United States Department of the Interior
NATIONAL PARK SERVICE
Air Resources Division
P.O. Box 25287
Denver, Colorado 80225

July 13, 2012

EPA Docket ID: EPA-R08-OAR-2011-0114

The National Park Service (NPS) has reviewed the Environmental Protection Agency (EPA)'s proposed "Approval, Disapproval and Promulgation of State Implementation Plans; State of Utah; Regional Haze Rule Requirements for Mandatory Class I Areas" published in the Federal Register on May 16, 2012. We previously commented to the State of Utah on August 1, 2008 and March 4, 2011 on the proposed state implementation plan.

Class I Areas within 500 km of Hunter PP

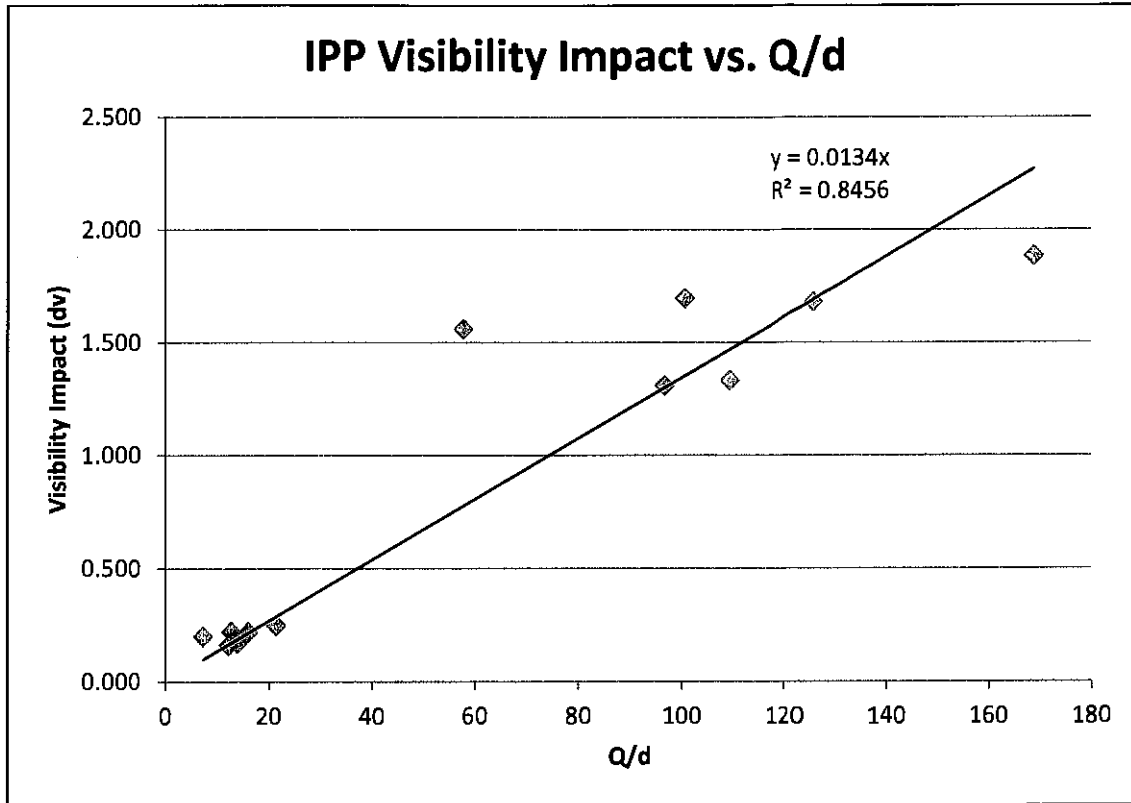
Hunter Unit 3: Hunter Units 1 and 2 are 430 MW each and subject to BART; Hunter Unit 3 is a 460 MW unit that was constructed after the close of the BART eligibility period. Hunter Unit 3 is 75 km from Capitol Reef National Park and, in 2011 had emissions of 3,406 tons of NO_x. Applying Q/d for NO_x emissions from Hunter Unit 3 yields a Q/d value of 70 at Capitol Reef NP. The Q/d values for Hunter Units 1 and 2 are 99 and 77, respectively, at Capitol Reef NP. Although we have no modeling results for Hunter Unit 3, WRAP modeling of 2002 and 2003 emissions from Hunter Units 1 and 2 estimated 2.145 and 1.905 dv impairments at Capitol Reef NP, respectively. With a similar Q/d, it is likely that Hunter Unit 3 also is a significant contributor at Capitol Reef NP. Using the Q/d = 10 threshold used by Wyoming, Hunter Unit 3 has a Q/d greater than 10 in an area³ greater than 500 km that includes Grand Teton NP and Craters of the

Moon NM and the Bridger, Fitzpatrick and Jarbidge Wilderness Areas, all Class I areas not on the Colorado Plateau. (See enclosed map.) Hunter Unit 3's NO_x Q/d at Craters of the Moon NM is 12. With a current NO_x emissions limit of 0.30 lb/MMBtu, Hunter Unit 3 is likely to cause or contribute to visibility impairment at Class I areas both on and beyond the Colorado Plateau. Emissions controls should be considered Hunter Unit 3 for reasonable progress.

Class I Areas within 500 km of Intermountain Power

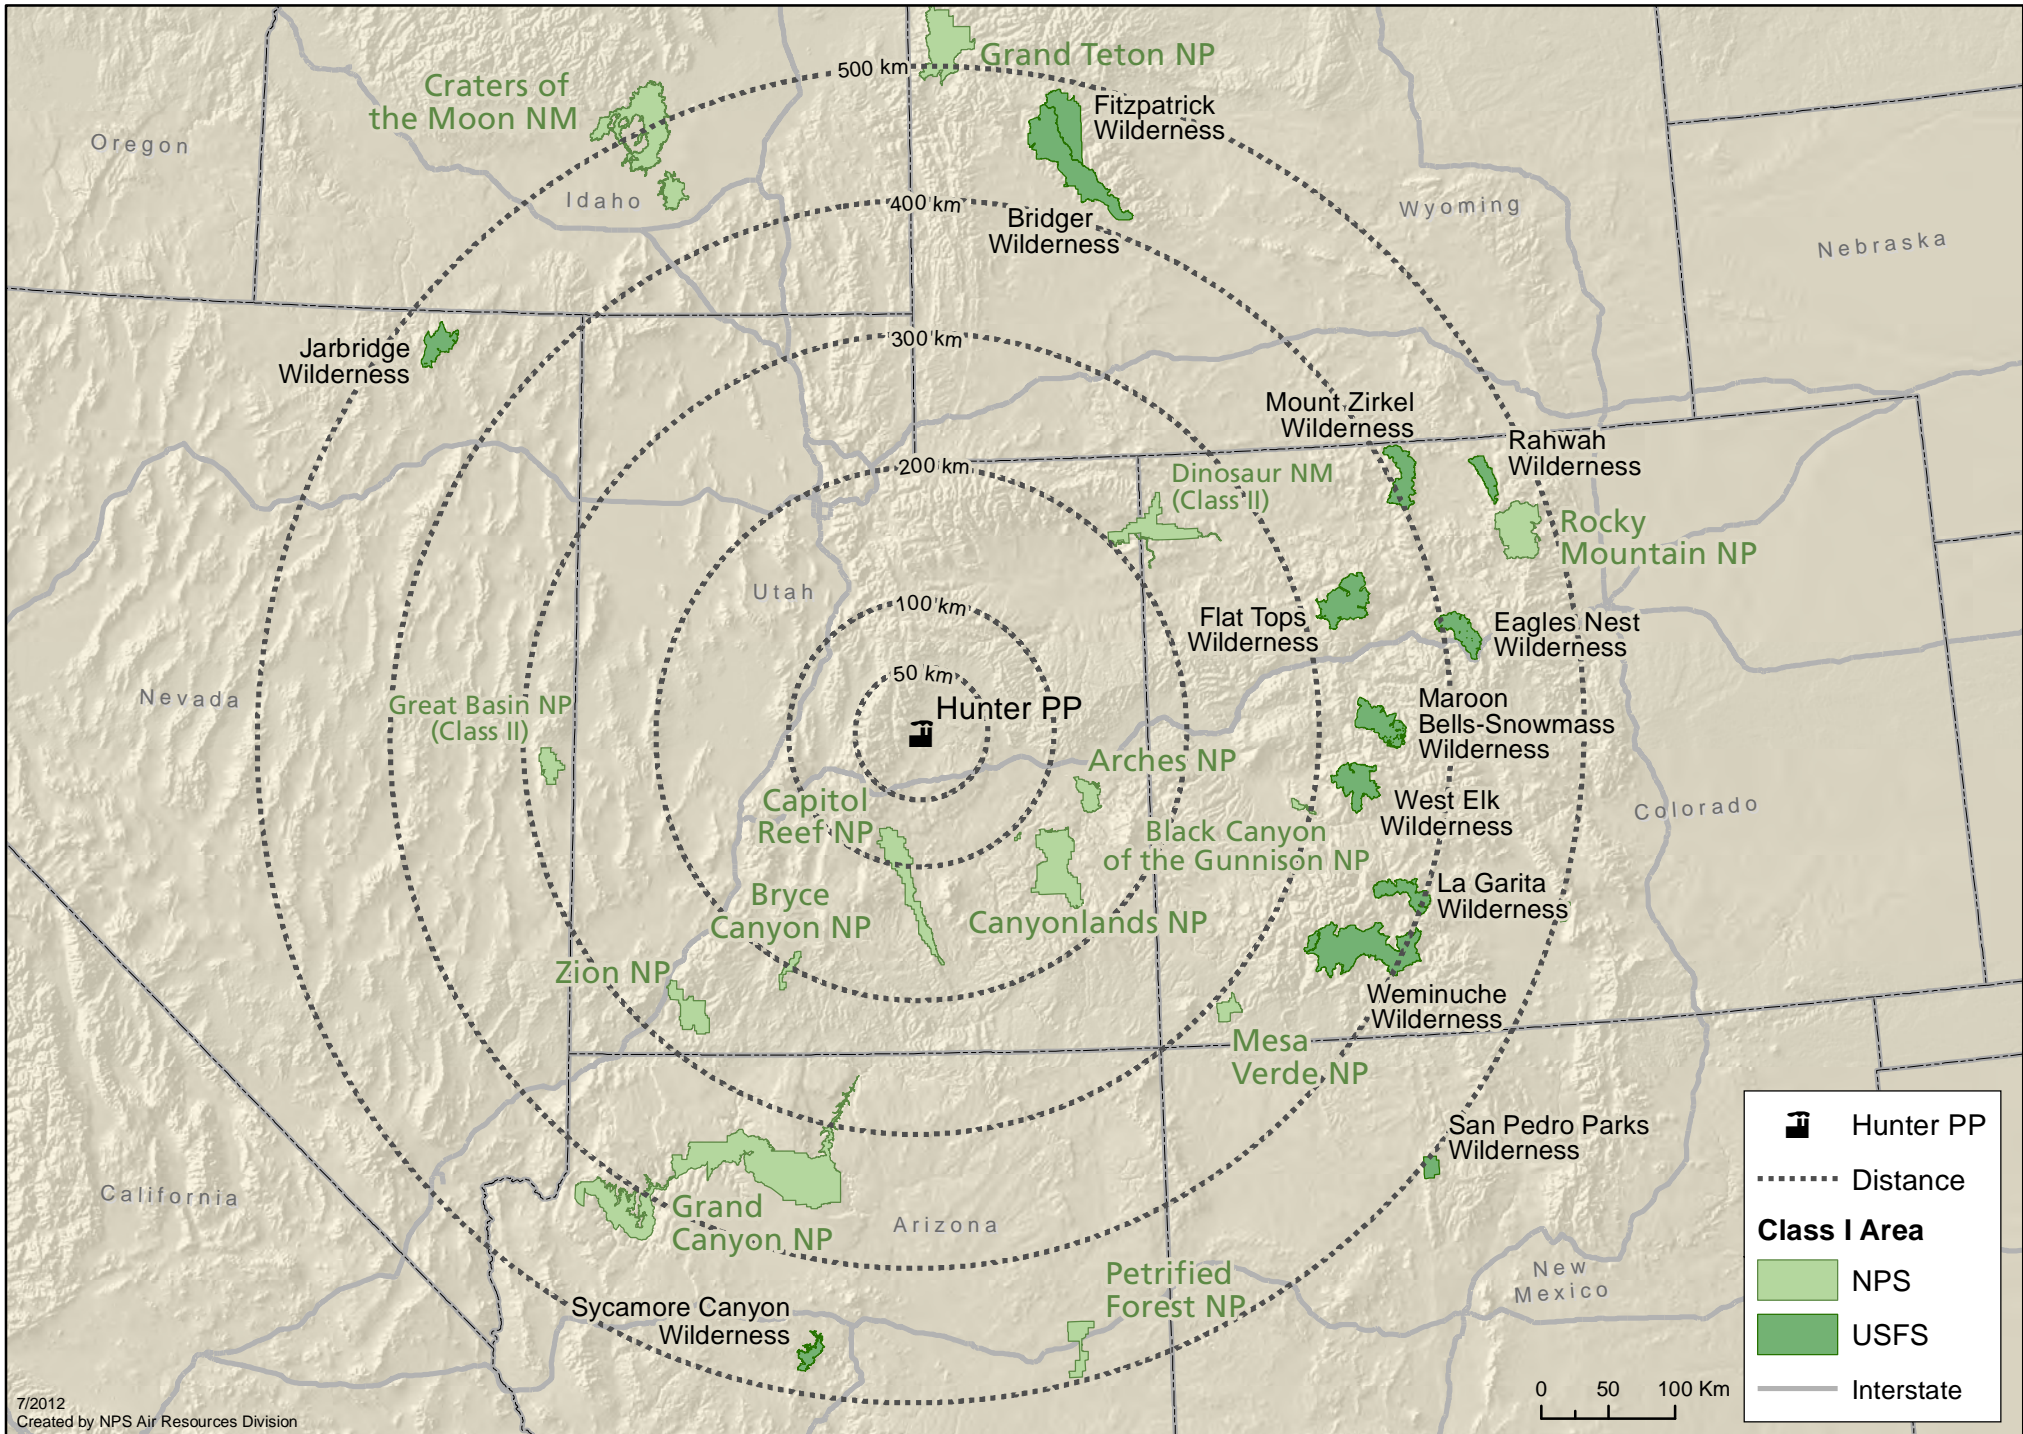
EPA R8 makes no reference to IPP in its current proposal. Applying Wyoming's Q/d approach to each IPP Unit 1 and 2, yields values at Capitol Reef NP (the nearest Class I area at 149 km) of 81 for Unit 1 and 88 for Unit 2. These values are 8 – 9 times higher than Wyoming's threshold to trigger analysis under the reasonable progress provisions of the Regional Haze Rule. Our modeling indicates that IPP Units 1 and 2 combined have a 2.4 dv visibility impact at Capitol Reef NP, with 1.9 dv attributable to NO_x emissions from IPP. IPP NO_x emissions have a Q/d greater than 10 in an area that extends beyond 1200 km and includes Grand Teton NP, Craters of the Moon NM and the Bridger, Fitzpatrick and Jarbidge Wilderness Areas, all Class I areas not on the Colorado plateau. IPP's NO_x Q/d at Craters of the Moon NP is 70 (see enclosed map). With the current NO_x emission limit of 0.40 lb/mmBtu and over 25,000 tpy NO_x, IPP is likely to cause or contribute to visibility impairment on and beyond the Colorado Plateau and control measures should be considered for reasonable progress.

While we do not currently have the files necessary to model the visibility impacts of emissions from IPP on Craters of the Moon NP (or on Jarbidge WA), we were able to model impacts at Class I areas on the Colorado Plateau and compare these results to IPP's NO_x Q/d at Class I areas. We modeled impacts using 2011 emissions from IPP and assuming installation of SCR for both IPP units. The figure below presents the correlation between visibility impacts (in deciviews, dv) from IPP NO_x emissions to IPP's NO_x Q/d for each Class I area modeled. Our results indicate that with a NO_x Q/d of 70, IPP could have a visibility impact greater than 0.9 dv at Craters of the Moon NP. Our modeling results are further described in Appendix A.
